MONTGOMERY COUNTY HISTORIC PRESERVATION COMMISSION STAFF REPORT

Address: 7402 Piney Branch Rd., Takoma Park Meeting Date: 02/22/17

Case Number: 37/03-17G Staff: Dan Bruechert

PROPOSAL: Driveway Replacement

Figure 1: 7402 Piney Branch Rd.

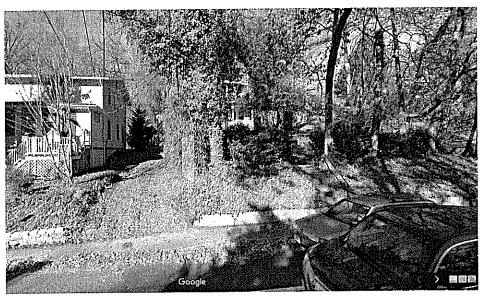
The current proposal calls for replacing the historic gravel driveway and replacing it with a contemporary concrete drive. The proposal will pave over the first 82 feet of the driveway and leave the remainder of the drive and parking area to the rear as gravel. The current driveway has a steep slope and is rutted in several areas.

Staff is generally supportive of removing the gravel drive; however, Staff feels that the proposed material will result in an appearance that is out of character with the surrounding district (per the Takoma Park Historic District Design Guidelines). The appearance created by the gravel drive shows an earthier color and includes texture which would be removed if a smooth, bright white, concrete drive was installed. A bright white concrete drive would draw attention from this historic house and creates an appearance that is incompatible with the surrounding district. Additionally, this change to the environmental appearance of the drive way would contravene the Takoma Park Historic District Design Guidelines by not respecting the environmental setting of the historic house.

The concrete used must contain an exposed aggregate to maintain a texture and tone similar to a dirt/gravel drive., with authority for final review and approval of the material delegated to Staff;
